ADDENDUM NUMBER 1 ON INVITATION TO BID ITB18KO-129

TITLE: Beaty East – Clean, Point and Seal

EXTERIOR ELEVATIONS BUILDINGS 'A' & 'B'
MEN'S & WOMEN'S DORMITORY
UNIVERSITY OF FLORIDA
GAINESVILLE, FLORIDA
STATE PROJECT UR-21 HFA PROJECT FLA-CH-7000

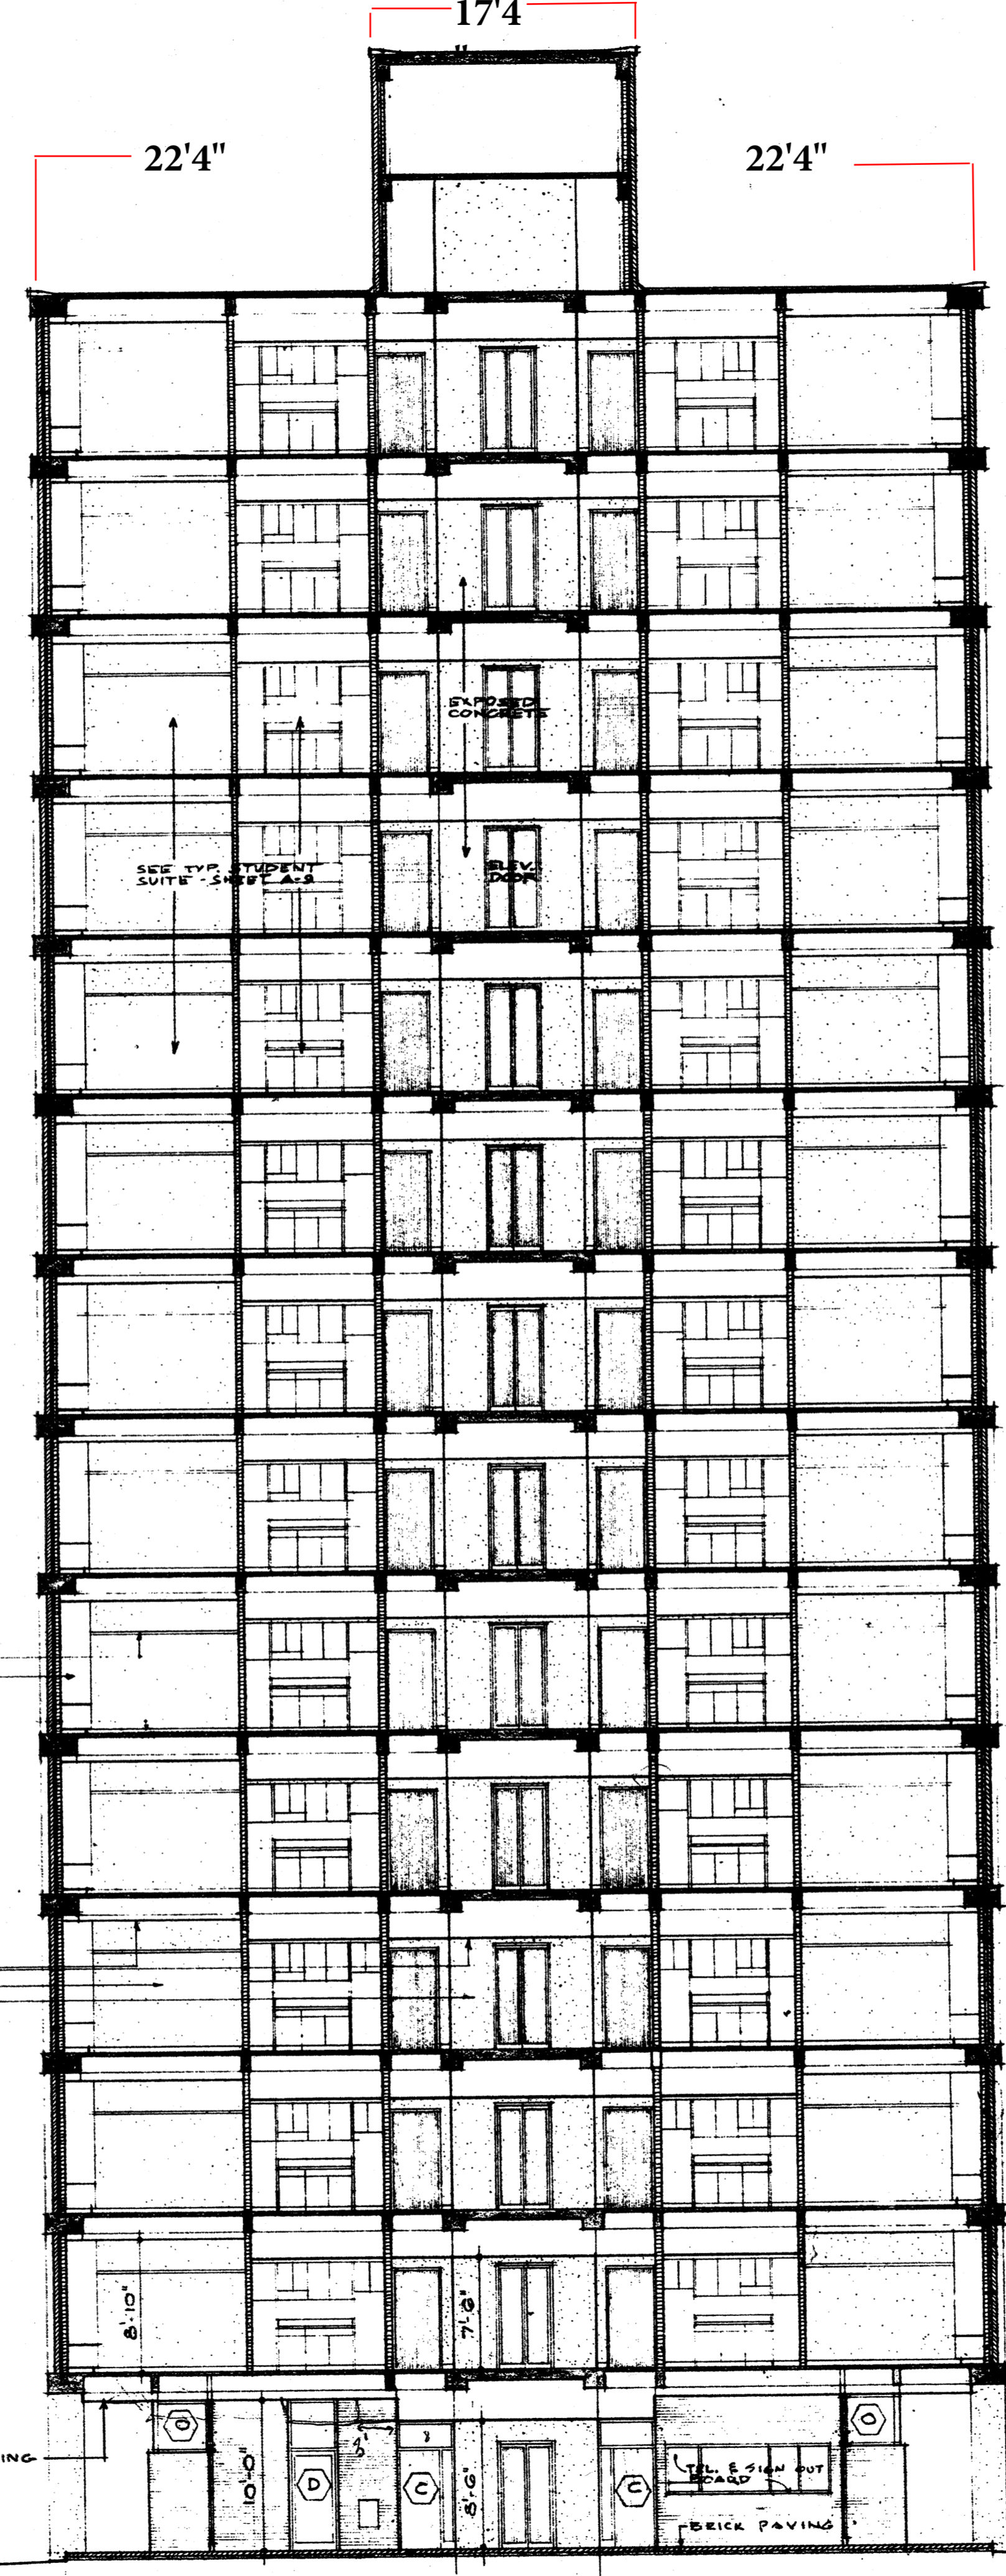
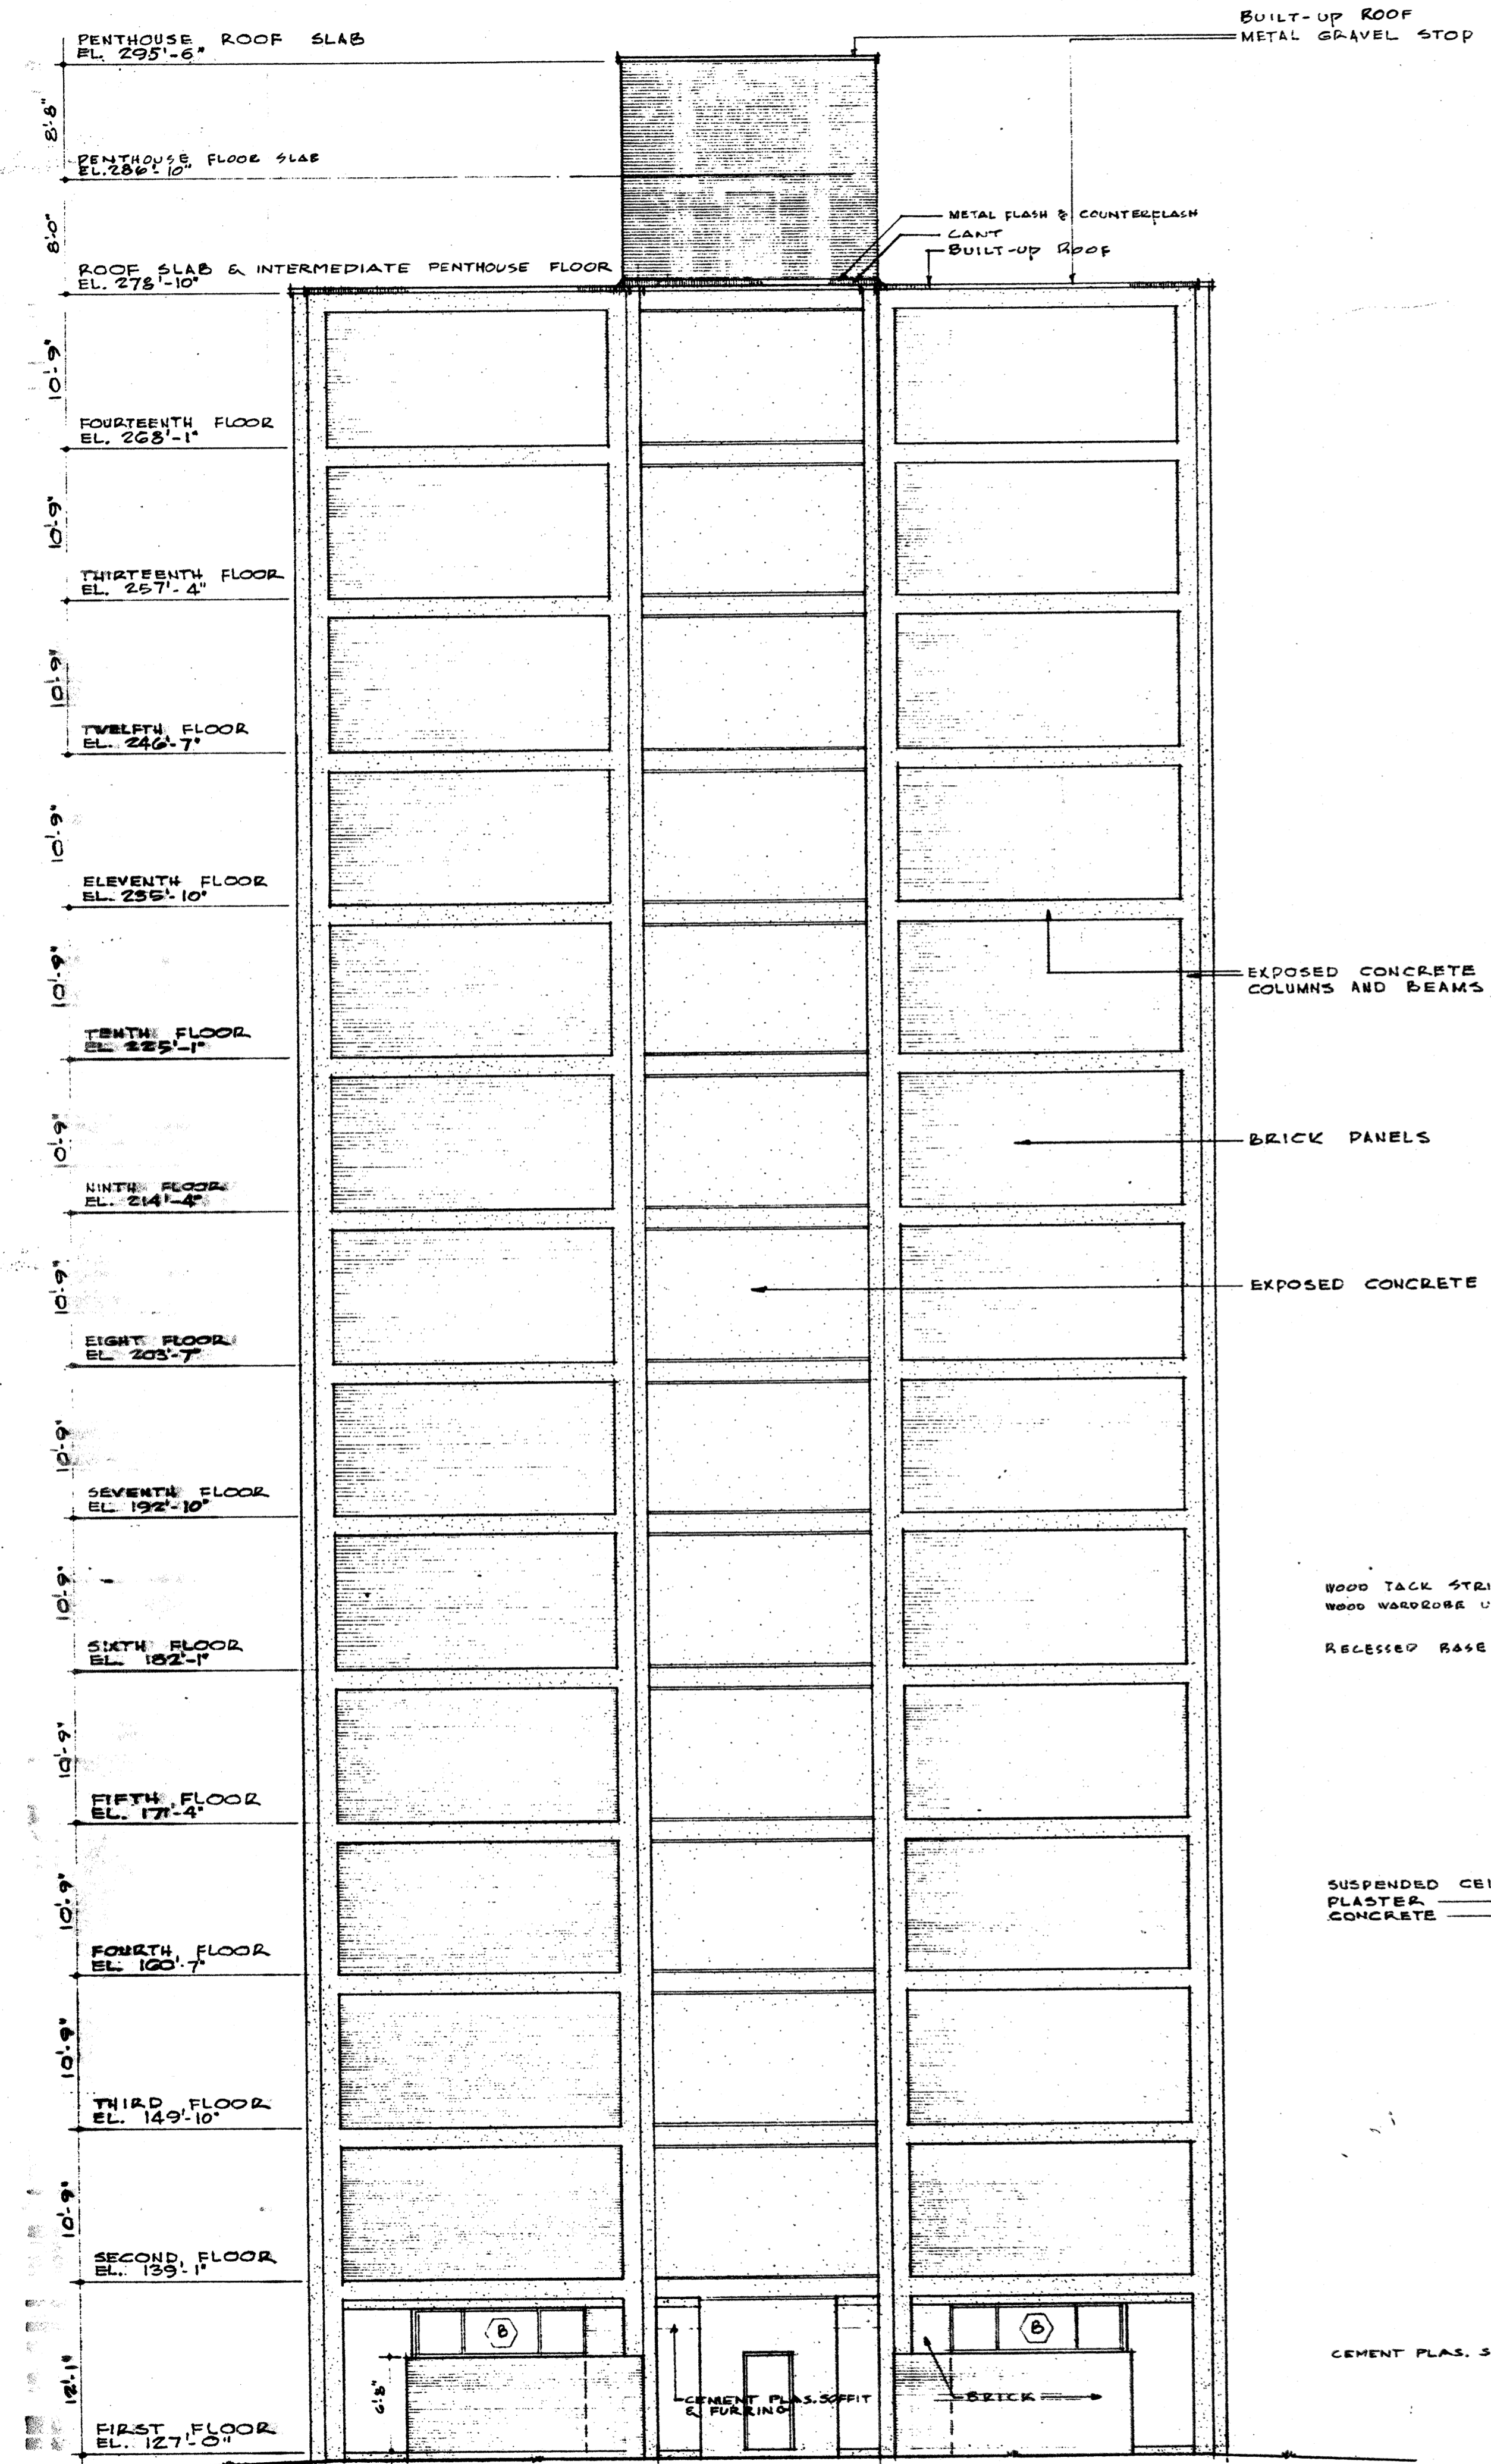
A12. North side - 600 square foot (include in base bid). South side - 600 square foot (include in base bid). East side - 300 square foot (include in Alternate 1). West side - 300 square foot (include in Alternate 2). Include a price per square foot for concrete beams and columns beyond what is included in the base bid. See revised Section 00310 – Price Page included in this Addendum.

A13. North side - 6000 lineal foot (include in base bid). South side - 6000 lineal foot (include in base bid). East side - 3000 lineal foot (include in Alternate 1). West side - 3000 lineal foot (include in Alternate 2). Include a price per lineal foot for point and tuck beyond what is included in the base bid. See revised Section 00310 – Price Page included in this Addendum.
